Planning Committee 2 December 2020 – Member Questions

<p>Item A: BH2020/00002 Coombe Farm, Westfield Avenue</p>		
1	<p>Why can't the CIL amount be agreed in advance of planning permission?</p>	<p>The committee have been provided with an estimated range of what CIL will be due as we have not yet been able to confirm with the applicant whether certain existing buildings on the site have been in their lawful use for at least 6 months in the last 3 years. If any/all of them have been (even partially), this enables the applicant to have the space omitted from the CIL levy calculations. In the case of this site, this is not insignificant due to the size of some of the farm buildings that exist on the site (hence the variance).</p> <p>The estimated value of CIL payment is being included in reports for planning committee members information, however, as it is a non-negotiable tariff applied through a legislative charging model, it is not a major planning consideration that the committee can take into account when making their decision.</p> <p>The estimate will be updated up to the point when the developer advises us of forthcoming commencement on site; at which point we will calculate the

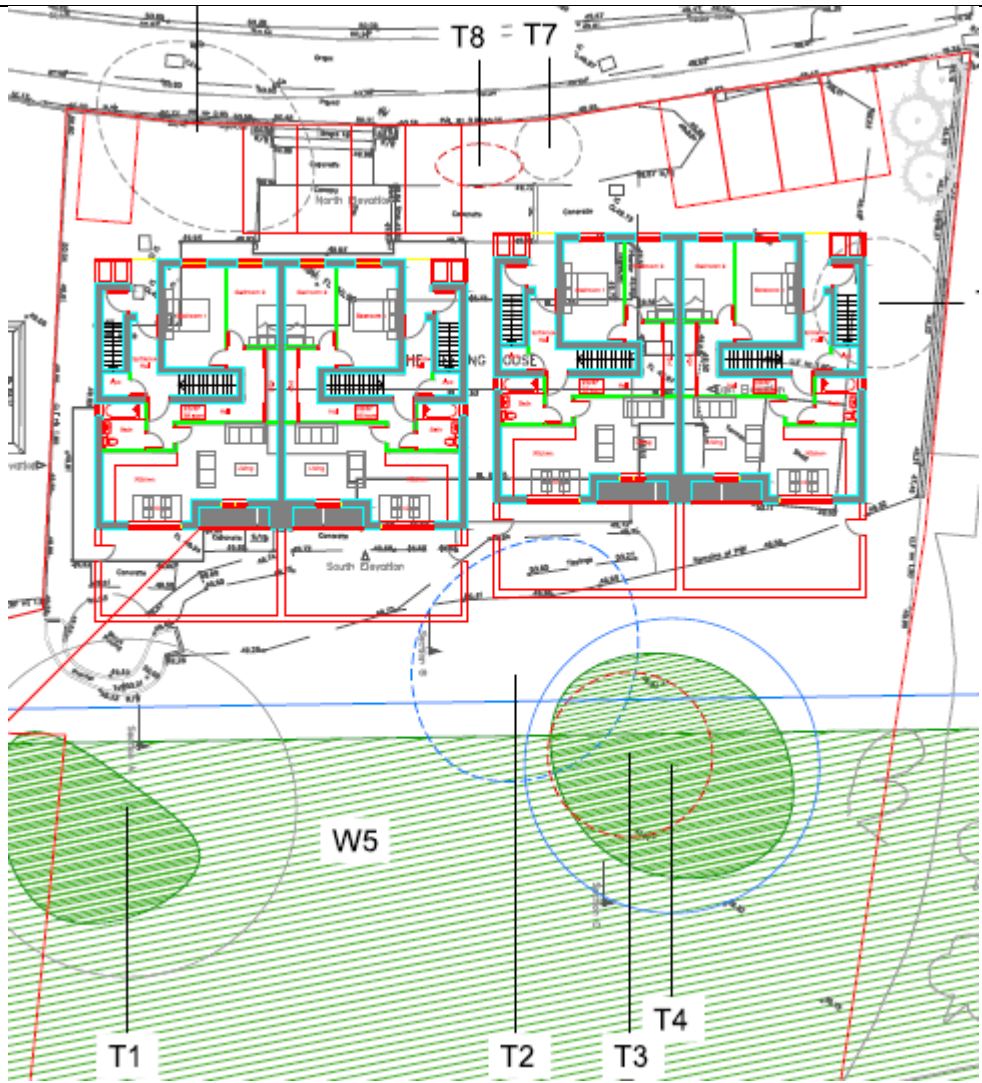
footway now extends for a greater distance along the southern side of the road before pedestrians are required to cross to the north side, which will benefit existing properties. From the junction with the road leading to the Kennels onwards, the alignment and layout differs.
Item B: BH2020/01742 The Meeting House, Park Close		
1	Can the T2 Ash tree at the rear be saved?	Please see plan below showing Tree T2 in very close proximity to the proposed development:

<p>The submitted Arboriculture Report states the following:</p> <p><i>“Rooting area conflicts with the new rear courtyard area and building foundations. Based on the likely loss of roots associated with excavations required for the building foundations and the site’s topography making use of an above ground hard surface difficult, T2 is not considered feasible to retain. A new specimen tree should be planted in a similar location to mitigate the loss of the T2.”</i></p> <p>The Council’s Arboriculture Officer has confirmed the following:</p> <p><i>“T2 is certainly plotted in close proximity to the proposed structure. It would be unlikely to survive post development due to root removal, canopy overhang and soil compaction. It looks near impossible to maintain an exclusion zone; they would certainly need to redesign foundations and surface levels.</i></p> <p><i>Realistically with Ash dieback becoming prevalent, the tree is likely to require removal within the next 5 years on safety grounds, irrespective of development. I wouldn’t consider specifying retention as reasonable, and significant mitigative planting is the better option.”</i></p>
